ADDENDUM NO. 2

Reference: New Cedar City Liquor and Wine Store
Department of Alcoholic Beverage Control
DFCM Project No. 08227030

Addendum No. A02

New Cedar City, UT Liquor Store
Department of Alcoholic Beverage Control
Cedar City, Utah
DFCM Project No. 08227030

Sheet Title:
 REVISED WATER ENTRY LOCATION

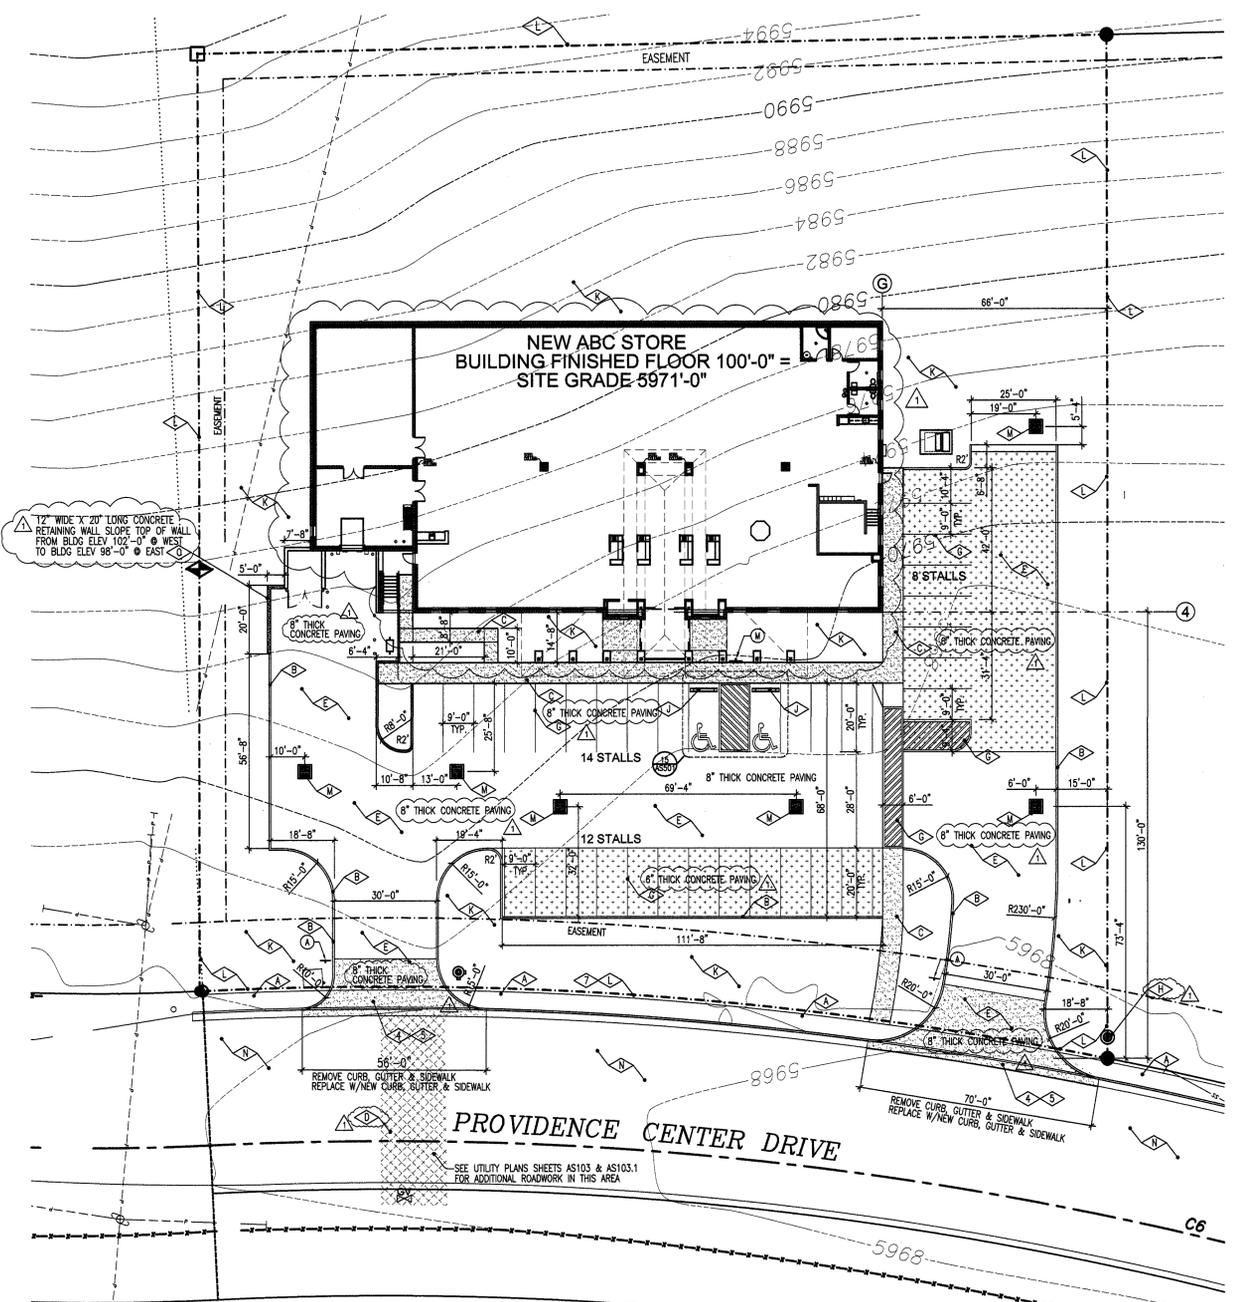
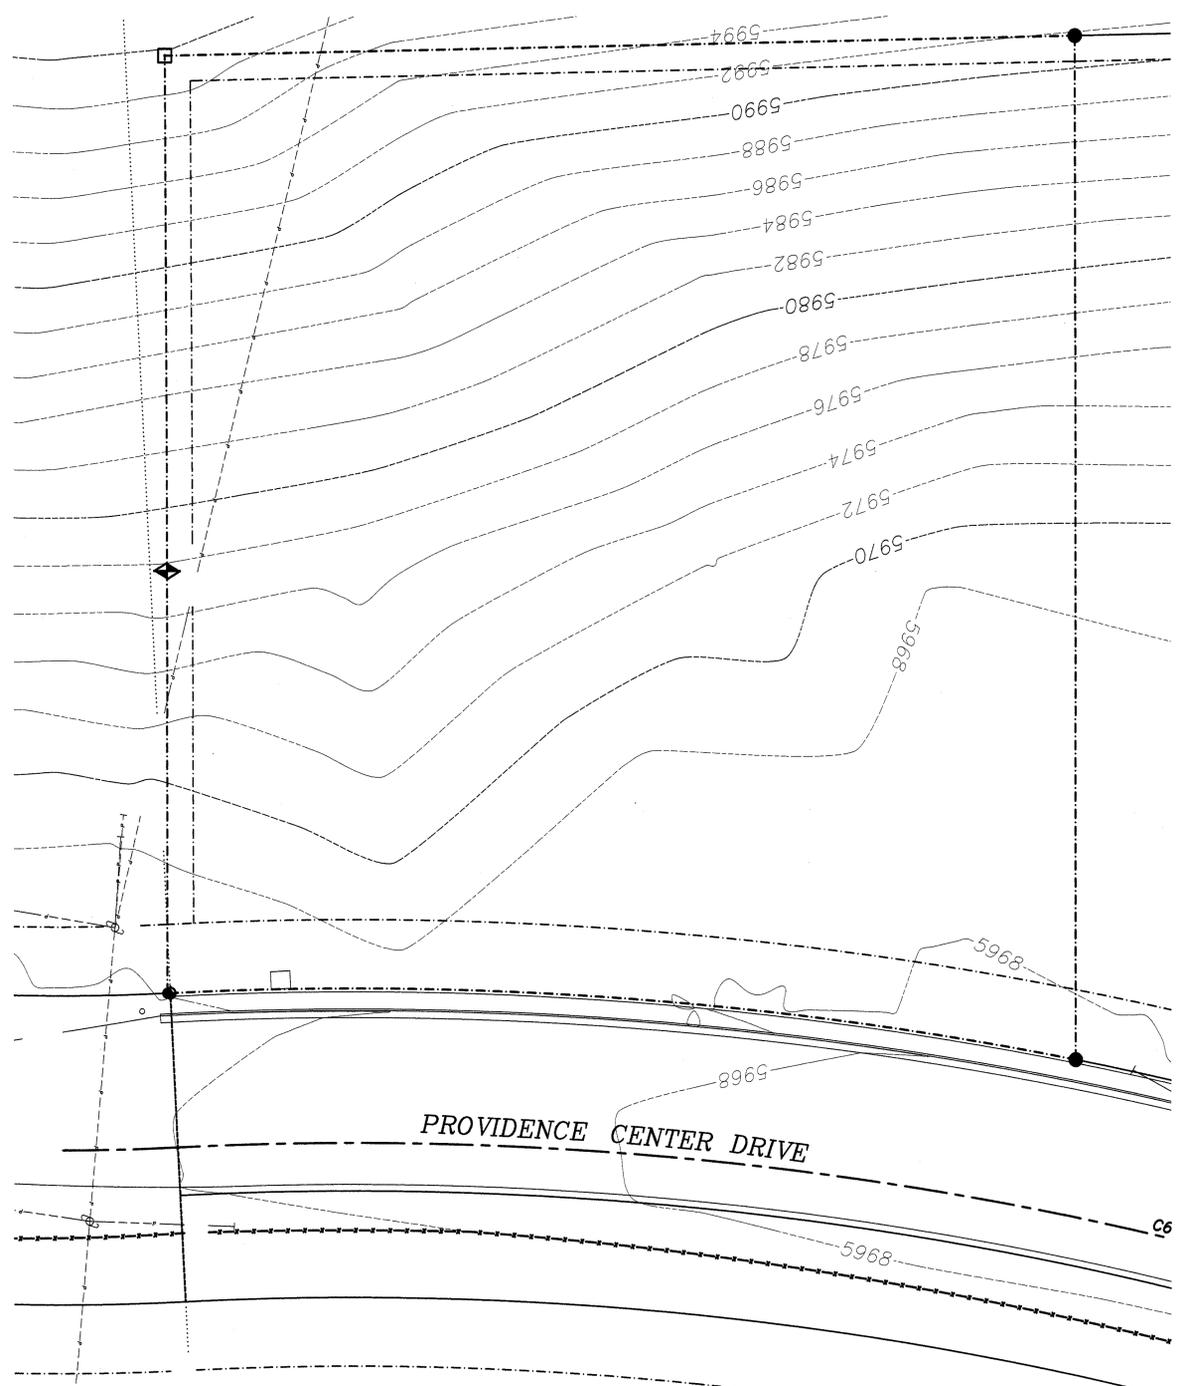
- d. Delete the exit sign shown along Grid C that notes the exit through the storage.
10. **Drawing AD-1 Revised Water Entry Location:**
- a. Drawing AD-1, showing the revised location of water entry and PVR station is attached to this addendum.

AS 102

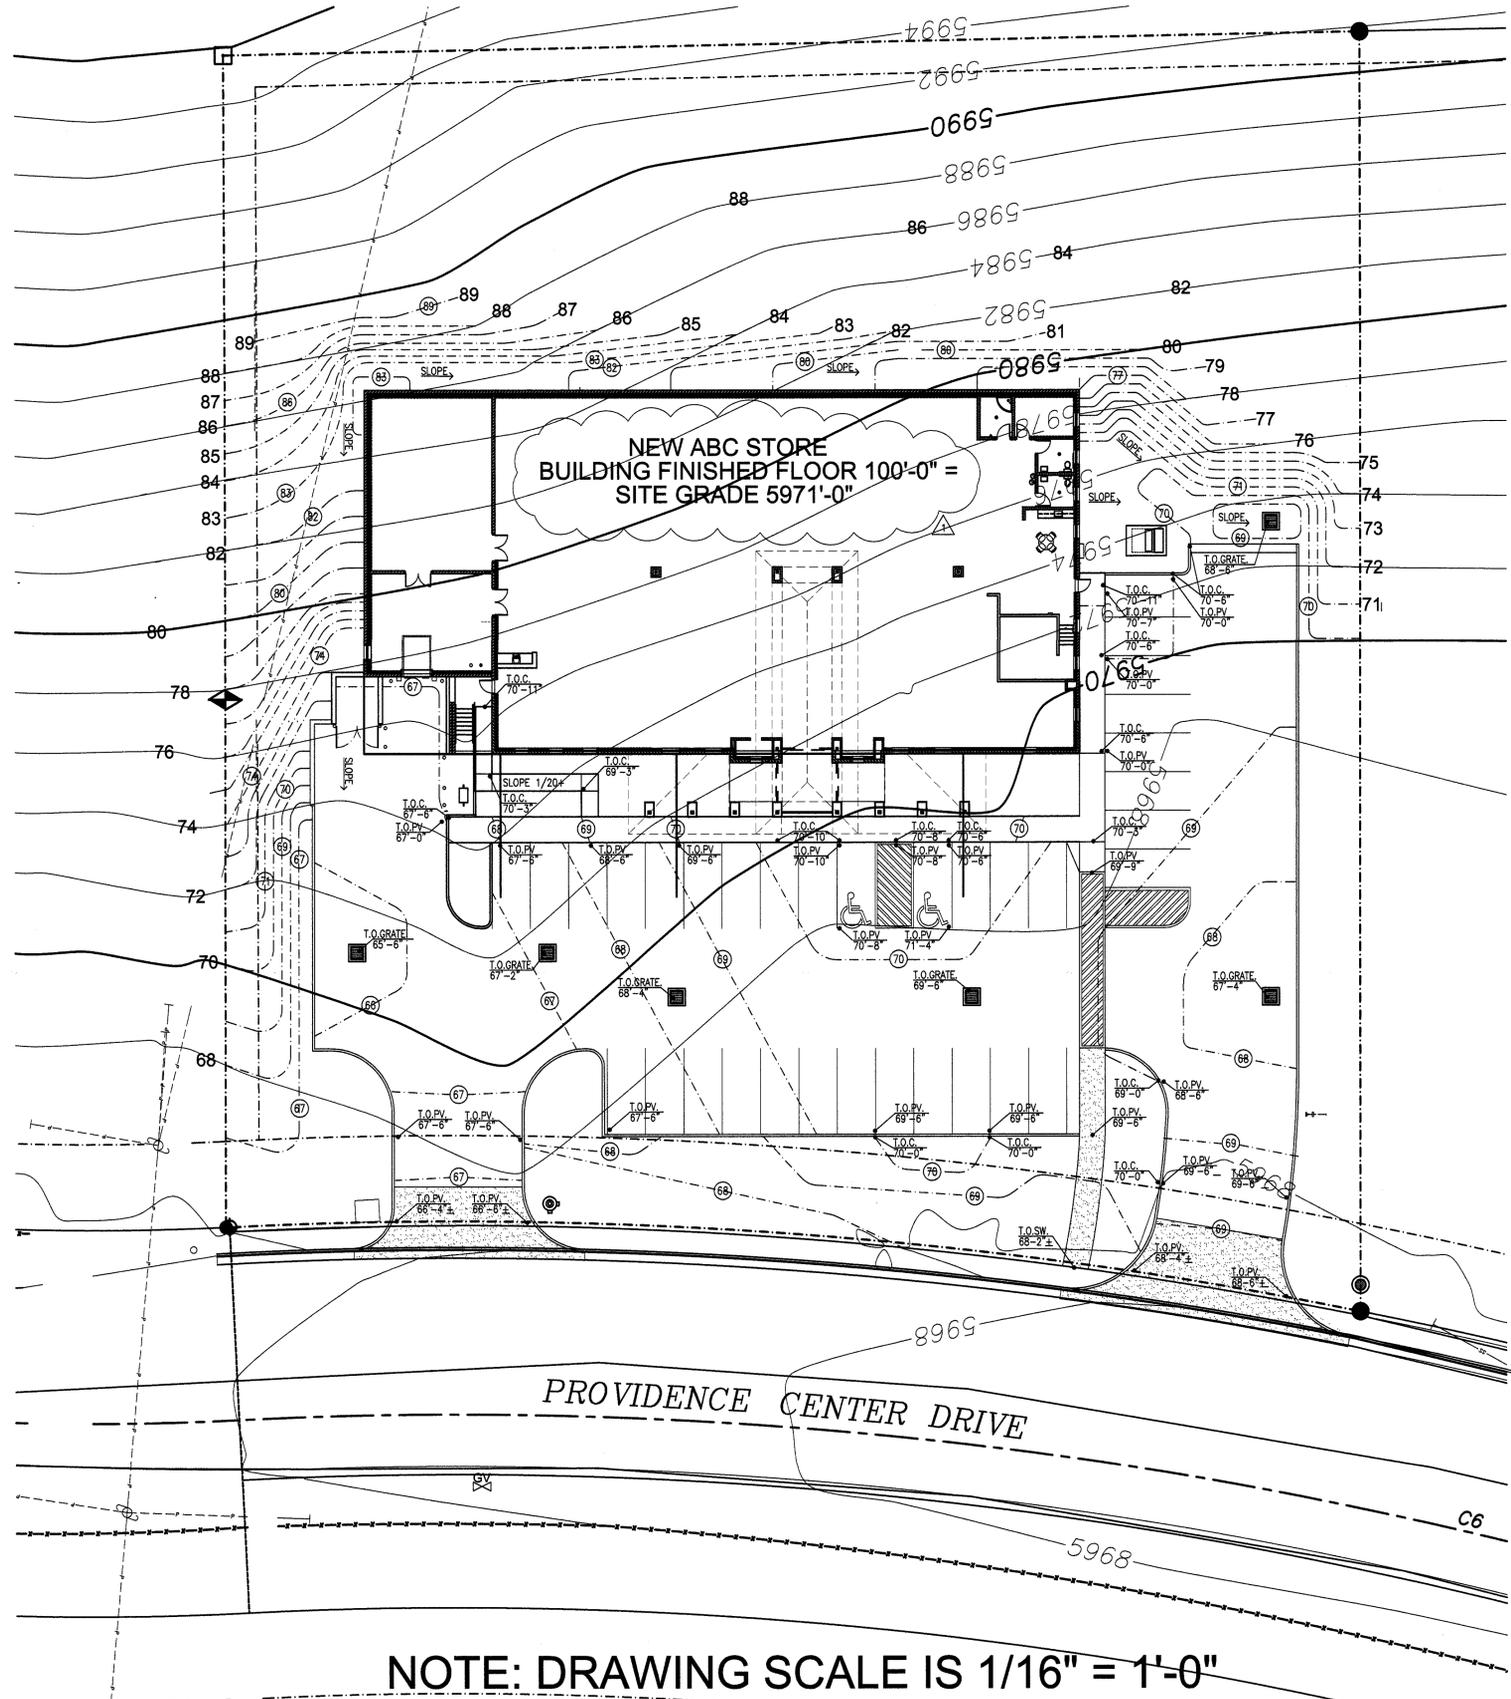
2. **Sheet AS102: Sheet AS102 is reissued with the following change:**
 - a. A note defining the site elevation and floor elevation relationship has been added to this sheet.

△ SITE GRADE AND FLOOR GRADE NOTE ADDED

AS 103

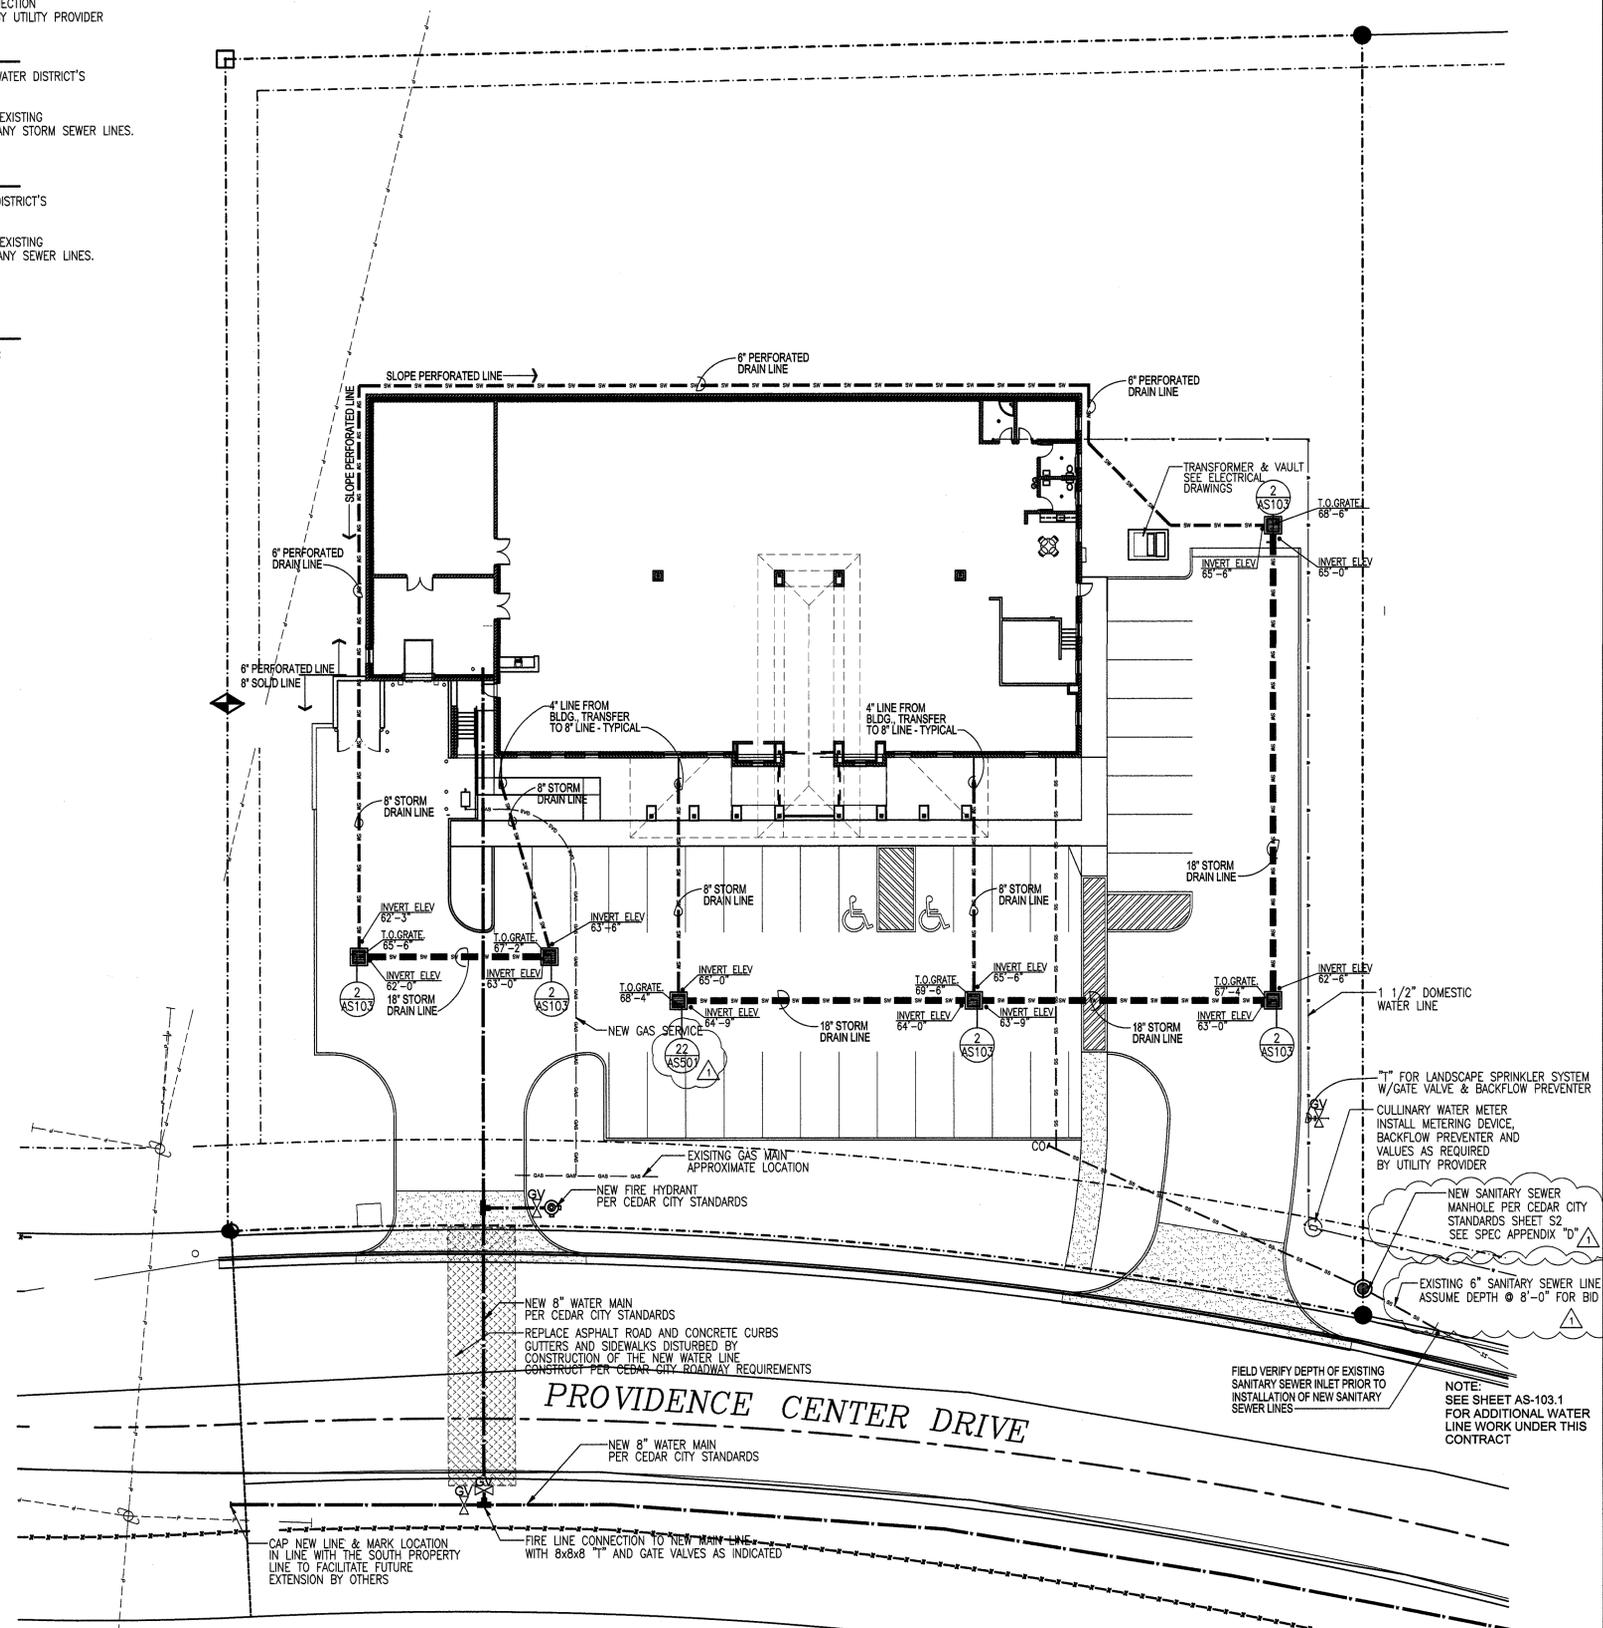
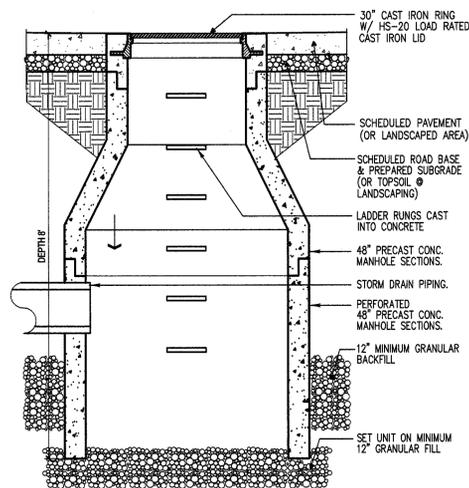
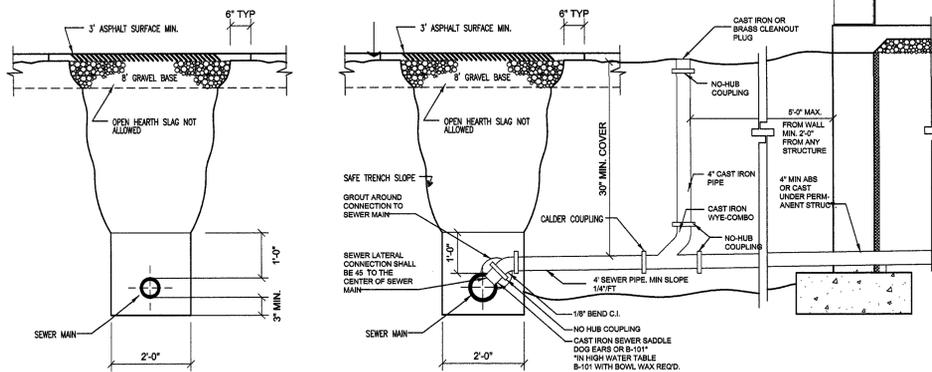
3. **Sheet AS103: Sheet AS103 is reissued with the following change:**
 - a. Notes and tags clarifying the dry sumps, catch basins and manholes have been added to this sheet.

- b. A sanitary sewer manhole has been added at the northeast property corner.

NOTE: SIZE OF EXISTING SEWER LINE NOTED DEPTH OF SEWER LINE FOR BIDDING LINE FOR ADDITIONAL WATER LINE WORK UNDER THIS CONTRACT
NEW SANITARY SEWER MANHOLE PER CEDAR CITY STANDARDS SHEET S2 SEE SPEC APPENDIX "D"
EXISTING 6" SANITARY SEWER LINE ASSUME DEPTH @ 8'-0" FOR BID
NOTE: SEE SHEET AS-103.1 FOR ADDITIONAL WATER LINE WORK UNDER THIS CONTRACT
